Metropolitan Development Commission Regional Center Hearing Examiner (July 25, 2024) Meeting Agenda

STAFF REPORT

Case Number	2024-REG-038
Address (approx.)	752 East Market Street and 730 Washington Street
Location	Center Township, Council Districts #13 and #18
Petitioner	1820, LLC, by Jeremy Stephenson
Zoning	CBD-2 (RC)
Request	Regional Center Approval for the renovation of two former industrial buildings into mixed-use structures, with new windows and masonry reconstruction, and providing for 30,000 square feet of commercial space, 213 dwelling units, amenities and utility space, and reconfigured surface parking areas.

SITE PLANS
COLE MOTOR REDEVELOPMENT
30 JUNE 2024

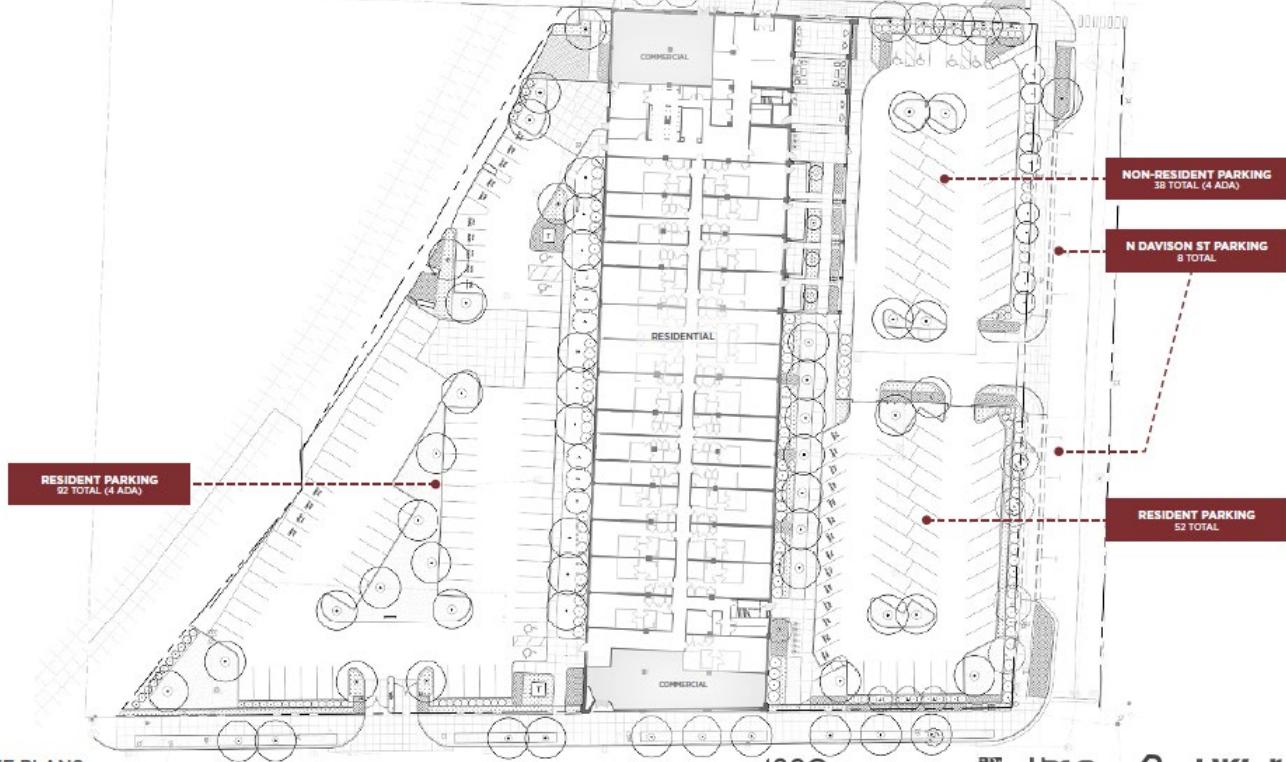
5. No details or locations of bicycle parking, either for interior storage for residents or outdoor bicycle locations for visitors, were submitted to the file. An amended site plan and floor plan noting these locations shall be submitted and subject to staff review and approval, prior to the issuance of an Improvement Location Permit. These Guidelines apply: CA 4.2.1, CA 4.2.2, and CA 4.2.4.

EXTERIOR ELEVATIONS: SOUTH BUILDING
COLE MOTOR REDEVELOPMENT
30 JUNE 2024

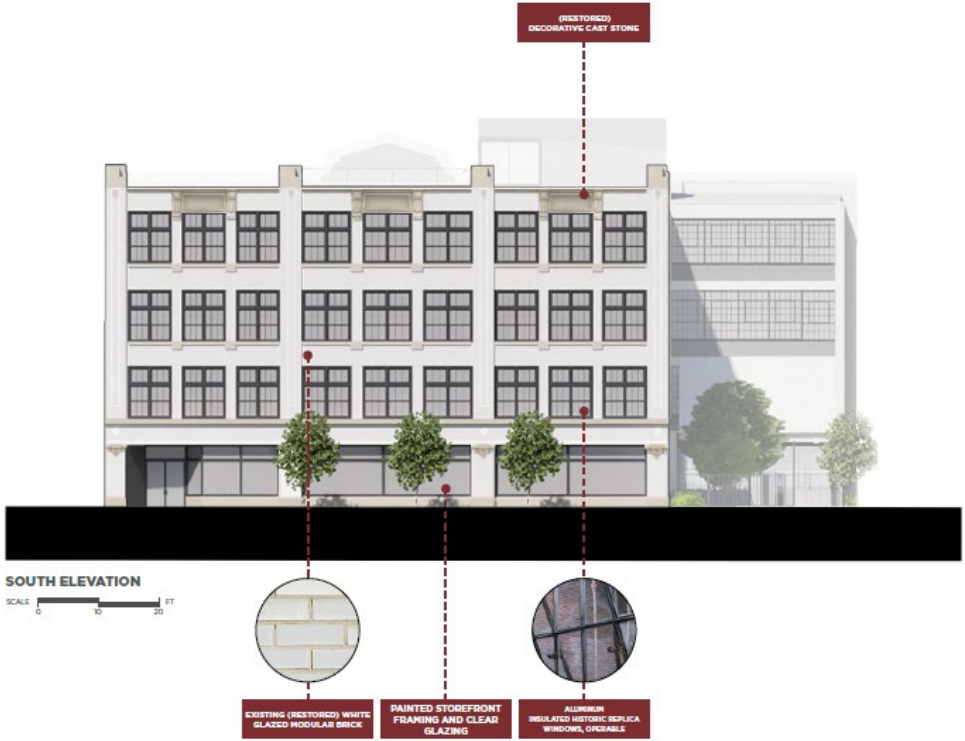
1. The submitted elevations do not provide details of some material items, such as the proposed decorative screening along the north and east elevations of the Cole South building. Therefore, scaled elevation drawings shall be submitted and subject to planning staff review and approval prior to the issuance of an Improvement Location Permit. Guidelines CA 2.1.1, CA 2.1.6 and CA 2.2.1 apply.
